Re: "DART+ West Electrified Railway Order 2022"

Please find attached my observation in respect of the above railway order pertaining the partial acquisition under CPO of Ashtown Stables for the purposes of a proposed access road at Ashtown due to the proposed level crossing closure at Ashtown.

Figure 1 Section B-B stable lands on left, Section C-C stable lands on right.

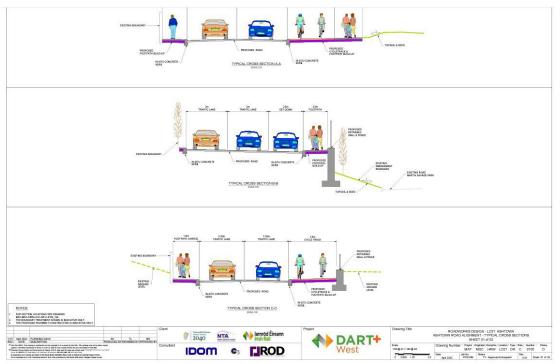
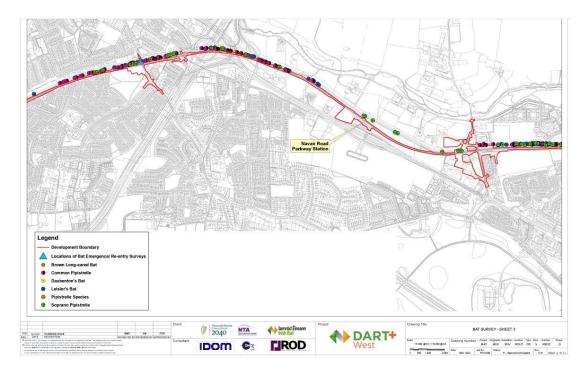
I welcome that item 4.1.1.1 Request for Avoidance of Relocation / Destruction of Ashtown Stables has been substantively addressed in the retention of Ashtown Stables in the current Railway order. However item 4.1.1.8 is of note here due to the high value biodiversity value of the site. In the submitted railway order the proposed works at Ashtown require a new access road and underpass to the west of the stables. This requires a partial CPO and temporary works CPO along the boundary condition of Ashtown Stables. The proposed development requires substantive tree and hedgerow removal from the southern portion of the lands of Ashtown Stables. No reference in the EIAR could be found in respect of mitigation vis a vis protected species on the lands of Ashtown Stables. No arboricultural survey appears in the publicly available documents online pertaining to the vegetation cover at the lands at Ashtown Stables. No detailed proposed planting plan has been presented in the publicly accessible documentation for Ashtown Stables. Section B-B for Ashtown on drawing 0105 appears to indicate the existing boundary is retained to the north eastern part of the lands. Section C-C requires a new boundary condition.

These drawings are schematic and lack detail. As no detail planting plan is proposed it is of concern as to the type of proposed species and specification of the any reinstatement planting. Some species such as oak for example are toxic to equines and are specified on the proposed planting schedules drawing, 15141.

The extent of land under CPO of the stable lands is not dimensioned where heavy intervention is proposed along the boundary condition. There is a lack of clarity on mitigation *if any* on the biodiverse integrity and green infrastructure of Ashtown Stables in the proposed Railway order for Dart West.

Figure 4 Top : Railway order Landscape impact drawing, Below: Railway order proposed mitigation . Note no trees noted for removal on southern part of Ashtown Stable lands under CPO in landscape impact drawing. These are noted for removal on the landscape mitigation drawing.

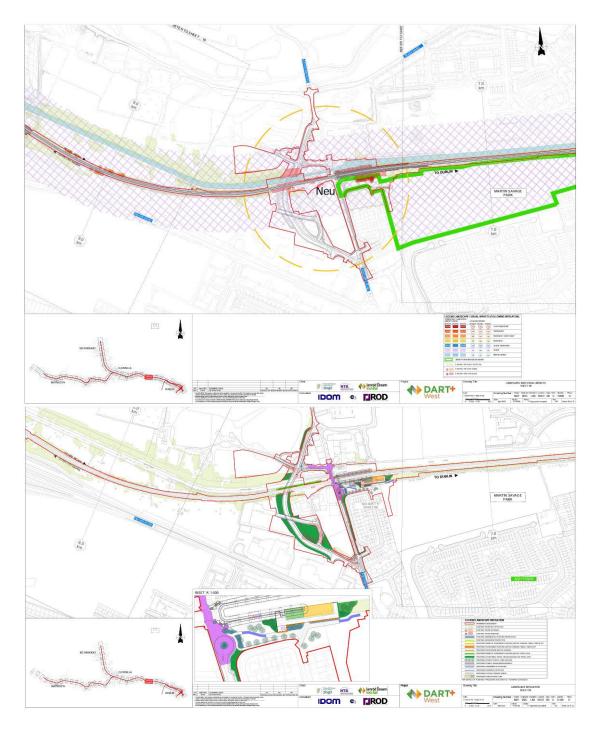
Here trees and hedgerows for removal are not documented in the landscape impact drawing yet is on the proposed mitigation plan. A new boundary condition is required to the south and south west. Yet the specific trees and hedging are not specified. For example *Quercus robur* (English Oak) and *Quercus palustris* (pin oak) are described as the type of trees that may be used as street trees on drawing 15108 . Both oaks are toxic to equines and demonstrates that no consideration was given to the planting scheme 15108 which pertains to Ashtown Stables. *Quercus palustris* is a non-native tree is inappropriate as a reinstatement of the native trees and hedgerow that are extant on the lands of Ashtown Stables. To the south west the existing vegetation, trees and hedgerow are noted as retained yet a new boundary condition is proposed on section C-C aforementioned. Any trees specified are at a maximum girth size of 10-12cm girth or maximum height of 2.5m tall or as whips at 900mm tall. 'Street' trees are a maximum size of 16/20cm girth (no height specified). 10-12cm girth is not a 'semi-mature' tree and whips at 900mm tall will be significantly poorer in visual amenity for the foreseeable future to that which the public currently enjoy. The meagre planting schedule presented cannot replace the current setting in any meaningful way.
